SOUTH TAHOE PUBLIC UTILITY DISTRICT

RECYCLED WATER FACILITIES MASTER PLAN

FINAL SUPPLEMENTAL - AUGUST 2011

Appendix T provides responses to comments received on the Draft SEIR and includes copies of the original comment letters received.

Figure 2.6: Diamond Valley **Overall Project Buildout**

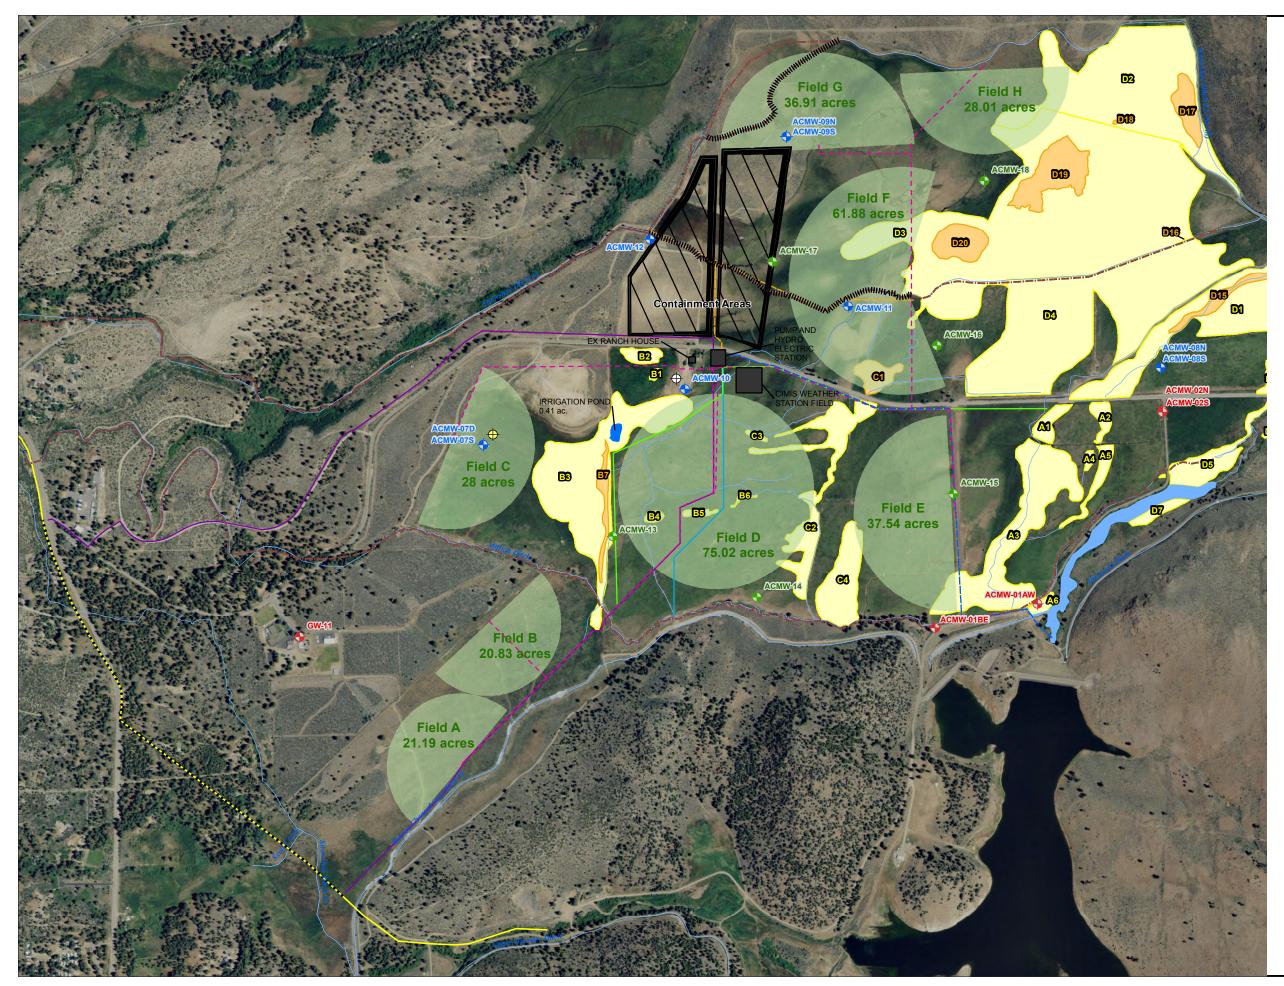
Page 2-3, DVR pipeline loop section and figure 2.6, discuss and show the new pipeline loop. The new DVR loop will drop in elevation and go through a pump house that at a later date may house a hydroelectric unit to produce electric power. Will the recycled water that flows through the pump house, need to be pumped from the pump house to Harvey Place Reservoir? Please discuss backup systems needed to pump recycled water back to Harvey Place Reservoir and means to avoid a discharge due to a pumping or power failure.

Irrigation Field G shown on figure 2.6 shows a portion of Snowshoe Thompson Ditch Number 2 going through the irrigated field. What has been proposed for altering the flow alignment and its possible impacts? Please include information on the evaluation of the ditch and whether the adjacent area around/ along the ditch is a wetland.

Figure 2.6 shows a portion of Snowshoe Thompson Ditch being replaced with an underground pipe, to allow the flow to go under Field 1, Field 2 and Field F. Please include information on the evaluation of the ditch and whether the adjacent area around/along the ditch is a wetland, including the area at the end of the pipe.

On Figure 2.6, between Field C and Field D there is a potential delineated wetlands shown. Adjacent to the wetland is a blue line for fresh water conveyance system. In other documents it has been proposed to place a tile pipe adjacent to that wetland. A tile pipe adjacent to that wetland could impact the wetland by desiccating the wetland, please provide information on what that blue line is indicating, its purpose, and evaluate the effects that it could have on the adjacent wetland.

Figure 2.6 shows a number of different red, black and blue lines, which reportedly identify Diamond Valley Recycled (DVR) pipelines, irrigation pipelines for recycled water, and fresh water pipelines, respectively, and it appears that some of those lines will connect. Fresh water pipelines designed to allow fresh water to flow into surface waters must not be capable of conveying recycled water. Please include this as a mitigation requirement.

This supplement to the EIR also added three additional irrigation fields, Fields A, B, and C as shown on figure 2.6 from the previous final EIR. If the ground water gradient in the area is known, then it should be disclosed in the final EIR.

Response: The District is planning to reroute Snowshoe Thompson Irrigation Ditch #2 (STID2) outside the west and north boundary of irrigation Field G. After the required segment of STID2 is moved outside the irrigation field, the existing segment will be filled and abandoned during land preparation for Field G. Figure 2.6 has been revised to show this change and is included in the final SEIR document. No lands have been mapped as wetlands through any area around/along this segment of STID2. The preliminary jurisdictional wetland boundaries that are identified on Figure 2.6 do not show any wetland areas surrounding the Snowshoe Thompson Ditch Number 2 in the vicinity of Field G, however the Ditch itself has been designated as an Other Waters of the US. Prior to implementation of this project in Phase II, sufficient mitigation will be required in order to offset impacts that may result from relocation and piping of this ditch.

Response: Figure 2.6 has been updated to reflect the ditch only being piped outside the wetland area. The District is generally planning to construct the buried portion of the ST2 Pipeline along the existing bed and grade of the Snowshoe Thompson 2 Diversion Ditch, to daylight at the western margin of the wetlands, east of the proposed irrigation improvements. The diversion ditch conveys surface water and is not believed to intersect the water table. Groundwater elevation monitoring indicates that shallow groundwater is typically greater than 10 feet below ground surface (ft bgs), across the upland portion of Diamond Valley and below the bed of the diversion ditch (west of ACMW-11). Therefore, the proposed pipeline trench is not expected to intersect shallow groundwater and should not change groundwater flow patterns beneath the adjoining wetlands.

Response: Groundwater flow directions across Diamond Valley have been inferred using groundwater level data collected from District monitoring wells; neighboring spring and stream bed elevations from USGS 7.5-minute topographic mapping; and estimated groundwater elevations along the basin fill-bedrock contacts surrounding Diamond Valley (Figure Q.1 below). Using these data, the groundwater gradient across the area of irrigation Fields A and B is directed to the north- northeast at an estimated rate of 0.03 ft/ ft. North of Millich Ditch, groundwater flow direction appears to rotate toward the east and groundwater gradients appear to flatten. The groundwater gradient across the area of Field C is directed to the east- northeast at an estimated rate of 0.01 ft/ft.
